Access Compliance Report Public Rights-of-Way (RR Crossings)

Intersection ID: 10034711	Main Street: POINDEXTER_DR	Location: N/A
ADA ID: 6AE14B98BBA3	Overall Compliance: No	Severity Score: 0.0
Codes/Mitigation Info/Possible Solution		Field Measurements/Component Compliance

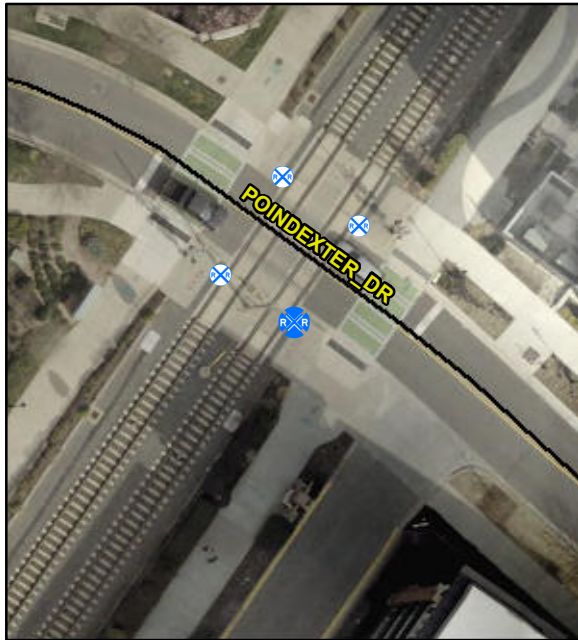
Remove & Replace Detectable Warning System. Provide Pedestrian Gate. Remove & Replace Walking Surface Adjacent to Rail.

Compliance	Description	Data
Yes	DWS Provided?	Yes
Yes	DWS Contrast?	Yes
Yes	DWS Width (in)	Yes
Yes	DWS Length (in)	24.0
No	DWS Offset (in)	11.0
No	Pedestrian Gate?	No
N/A	DWS Outside Gate?	N/A
N/A	Rail Type?	LightRail
No	Flangeway Gap (in)	3.0
Yes	Sidewalk Width (in)	81.5
